RZP-2021-082

4301 CRAIG AV, CHARLOTTE NC 28211

[Discipline: CHARLOTTE WATER]

Falcon Street Single Family Rezoning Site Plan

RZ-1.0

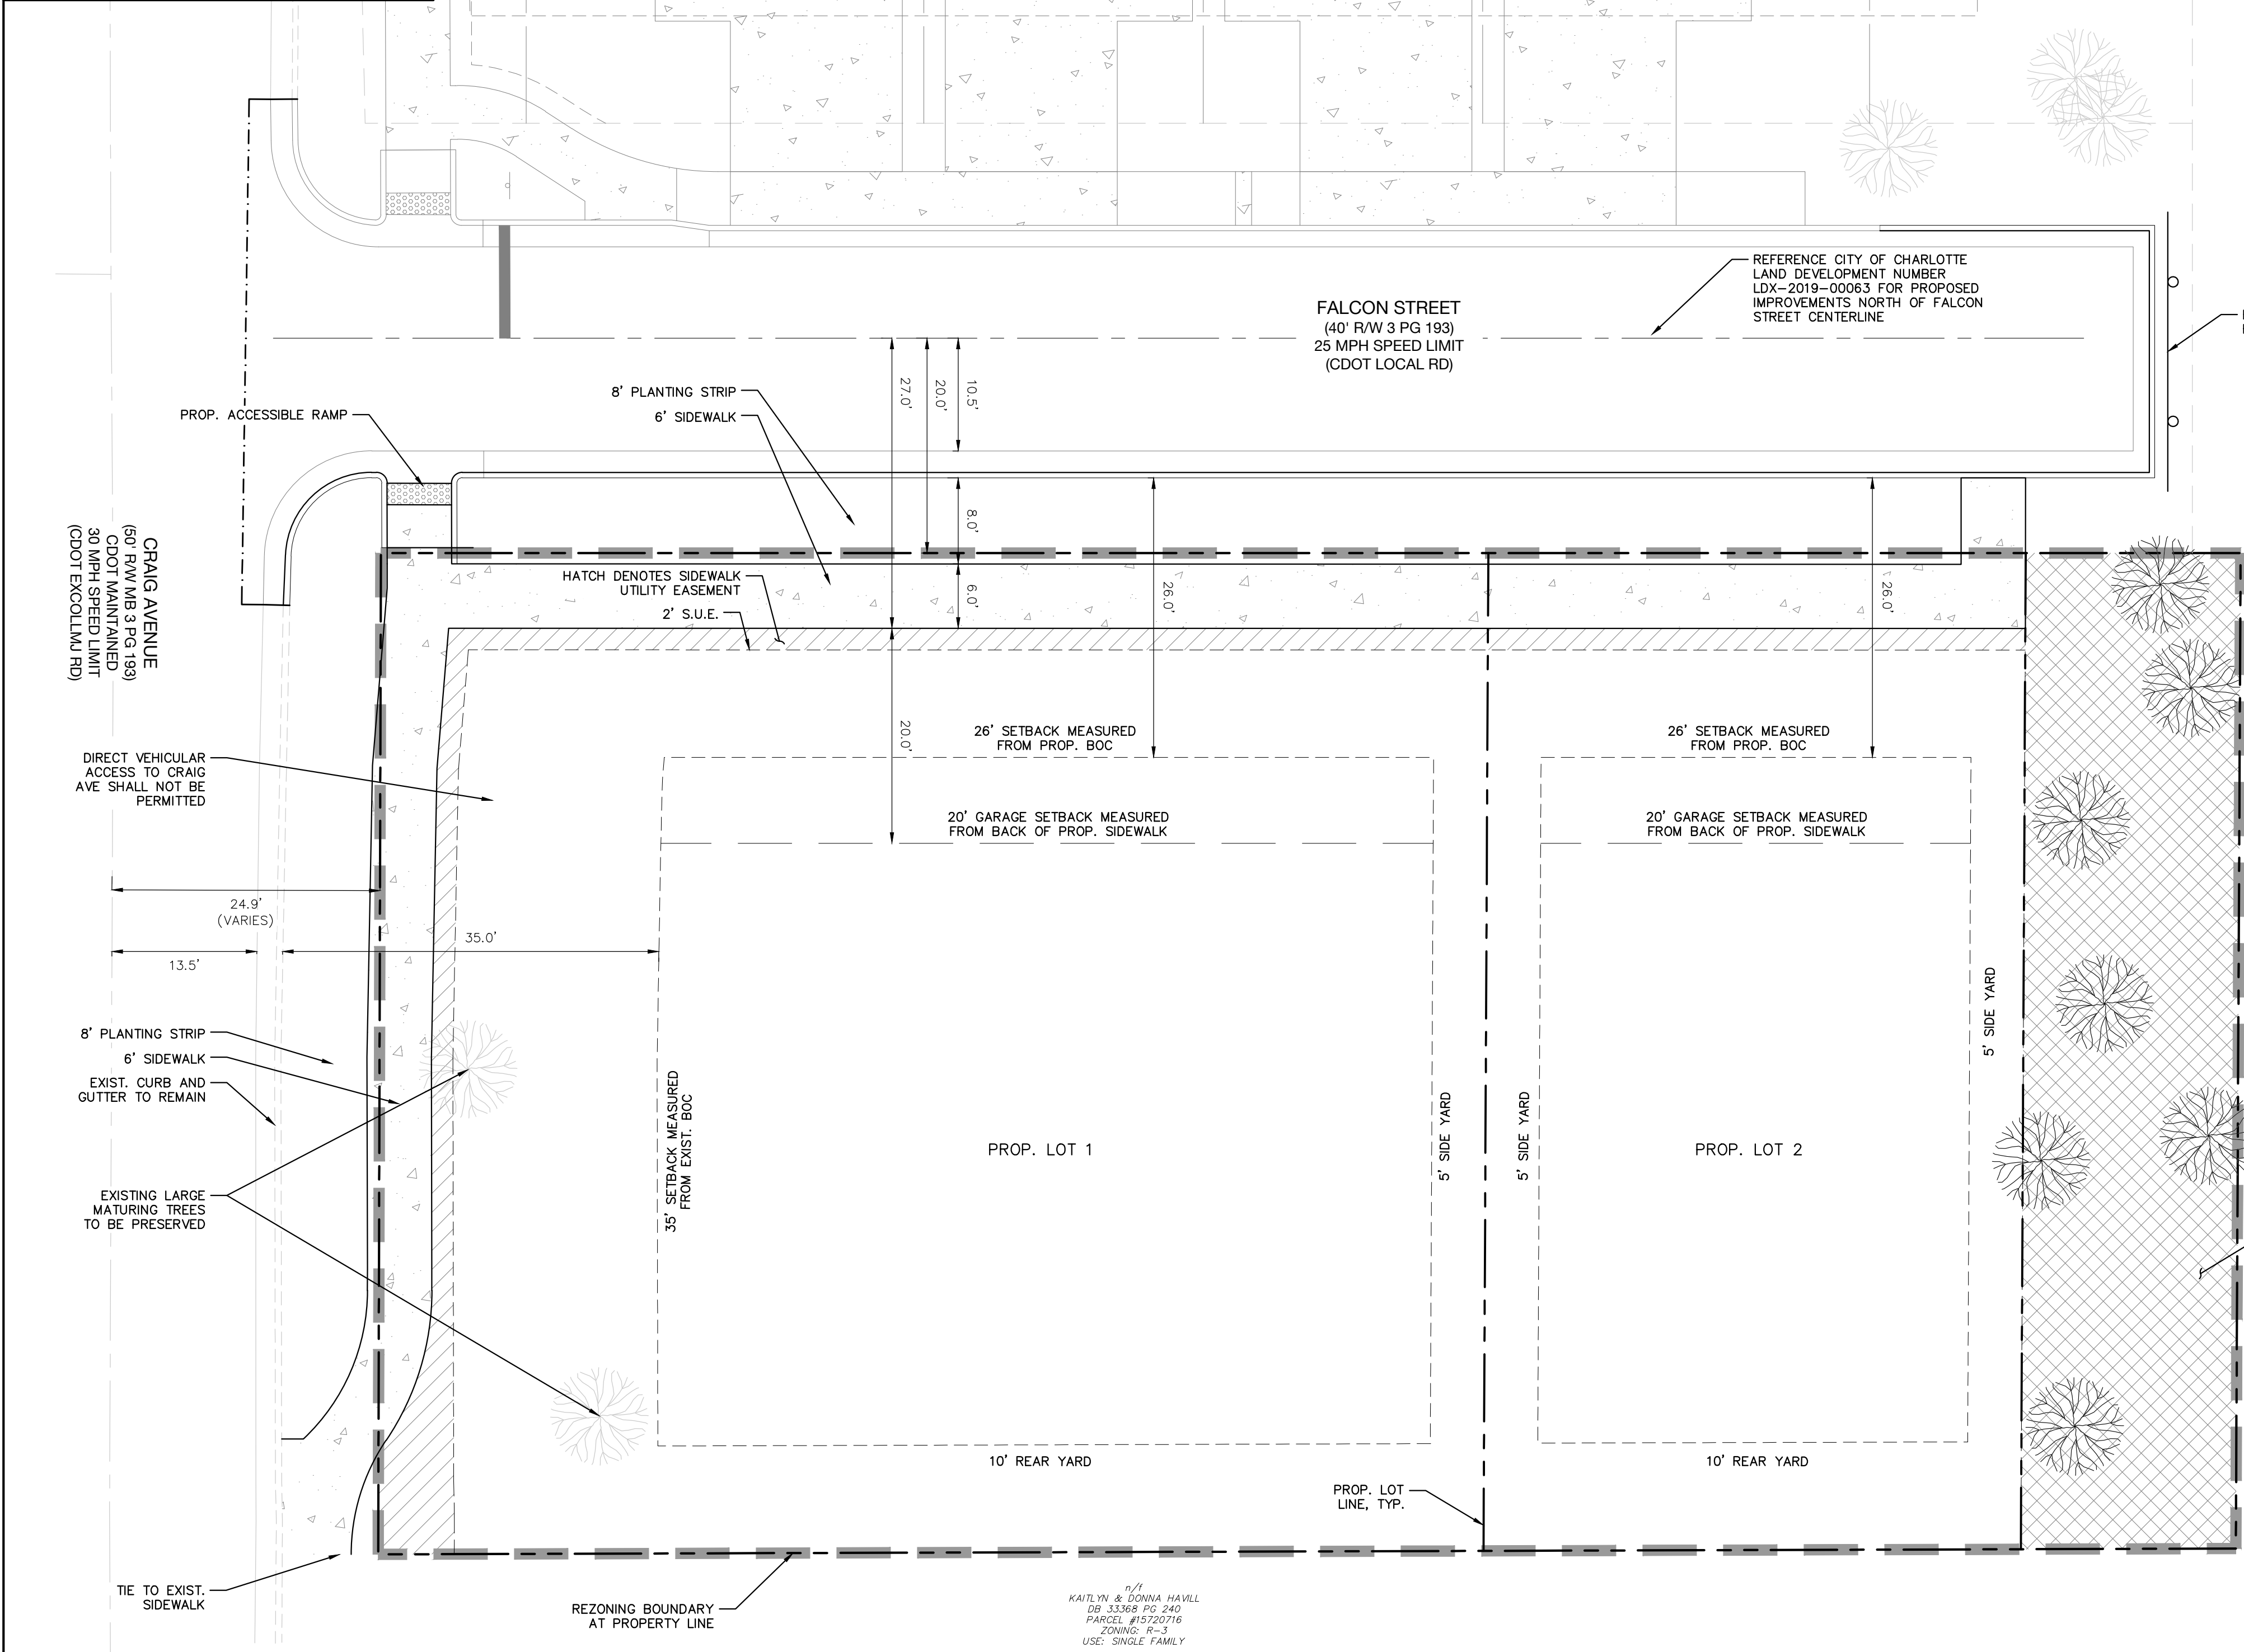
Charlotte Water has accessible water system infrastructure for the rezoning boundary via an existing 8-inch water distribution main located along Craig Ave.

Charlotte Water has accessible sanitary sewer system infrastructure for the rezoning boundary via an existing 8-inch gravity sewer main located along Craig Ave.

Development is encouraged to contact Installation Development Services at (704) 336-5499 to review service connection design requirements and City Ordinances (e.g., backflow, separate meter Ordinance, public/private pipeline extensions).
Comments: Has direct access to sewer. Has direct access to water. Contact CLT Water New Services Department for water/sewer services.

The Growth Development Policies (GDPs) call for a density between 6 to 8 dwelling units to the acre.
